Rezoning Transportation Analysis

Petition Number: 2020-086

General Location Identifier: Tax ID 04708214

Date	Description
07-22-20	First Review
10-26-20	Second Review
11-30-20	Third Review

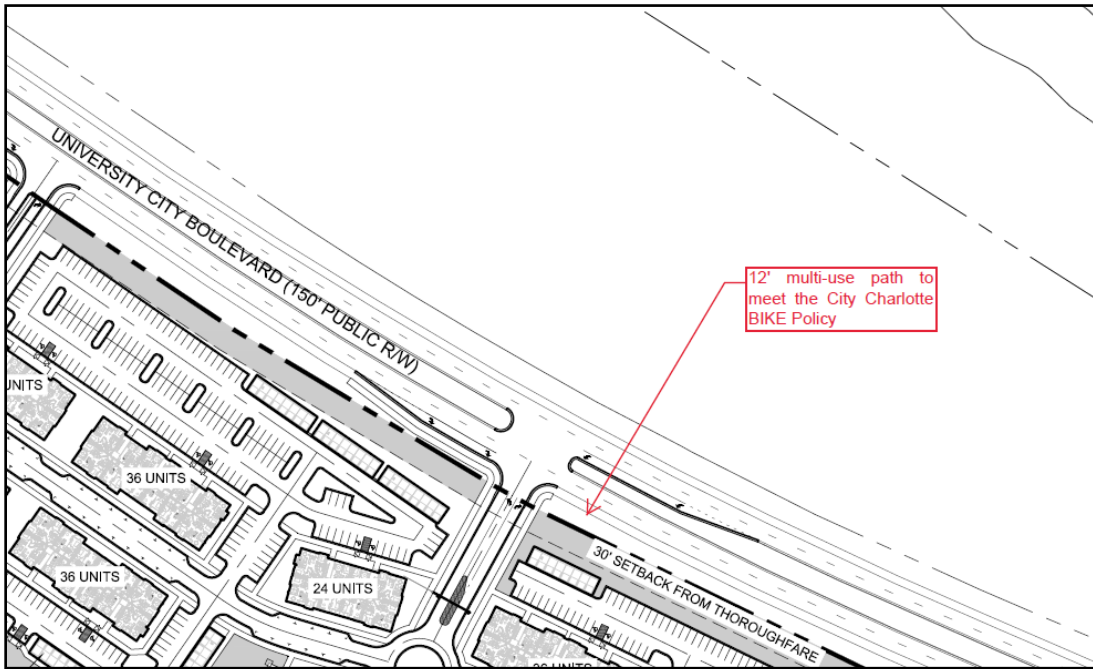
2. ~~**Traffic Study** A Traffic Impact Study is necessary for the complete review of this petition due to the site generation of more than 2500 daily trips.~~

Staff will receive the petition and begin work on it, but the public hearing will not be scheduled until the TIS is received. This will allow for the minimum time necessary for CDOT to review and approve the study and reach agreement with the petitioner on the required transportation commitments, ~~and have them included on the last site plan submitted no fewer than 4 weeks prior to the public hearing.~~ Therefore, additional traffic mitigation comments may be forthcoming once the TIS is approved by CDOT and NCDOT.

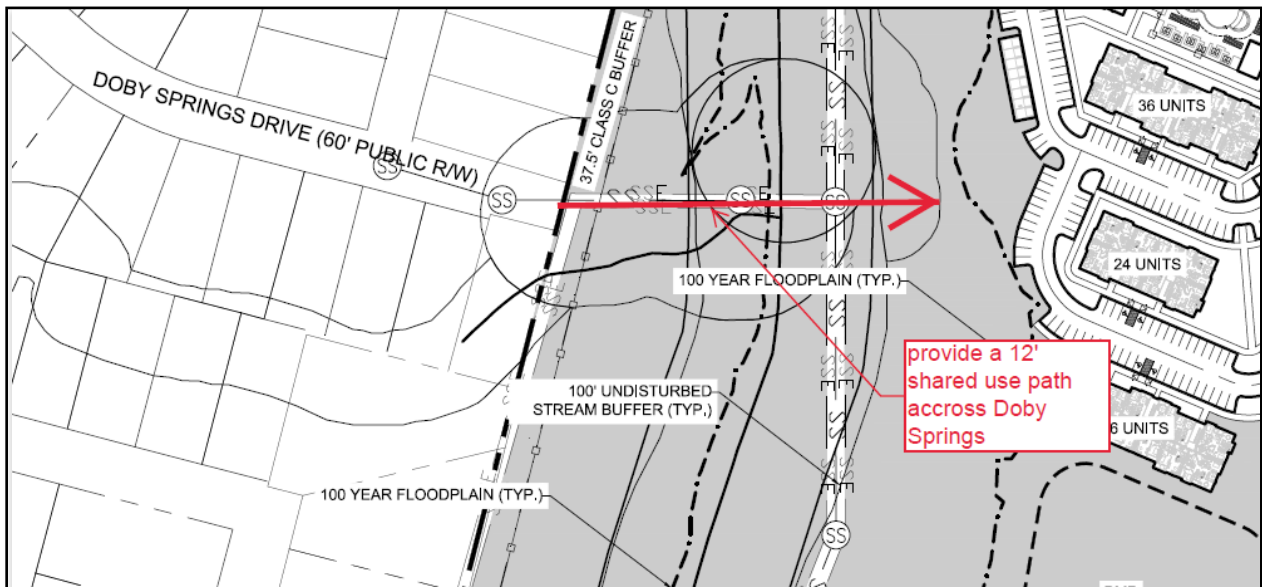
- The petitioner should revise the site plan and conditional note(s) to commit to installing a 12' multi-use path along the site's frontage on University City Blvd to meet the City Charlotte BIKE Policy.

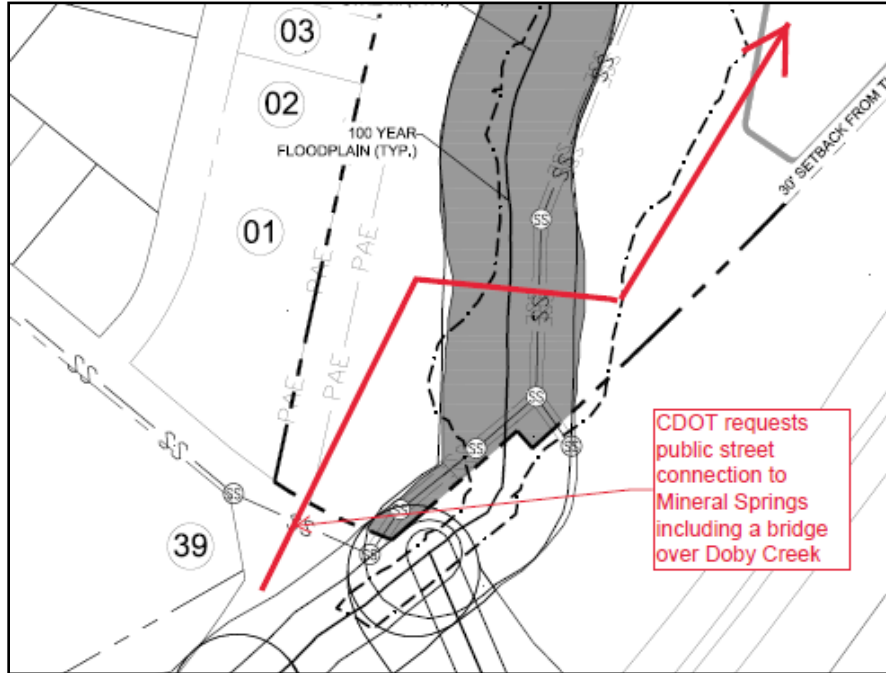
- The petitioner should revise the site plan and conditional note(s) to commit to constructing a shared use path from Doby Springs Drive including a structure over Doby Creek to provide pedestrian and bicycle access to adjacent subdivision in accordance with the Charlotte WALKS Plan and Charlotte BIKES Plan.

- Revised Comment (site plan dated 10/12/2020)** Revise the site plan and conditional note(s) to commit to constructing a **Public street shared use path** connection to Mineral Springs Road, including a box culvert over Doby Creek, to improve connectivity by providing a north-south connection to access University Blvd.
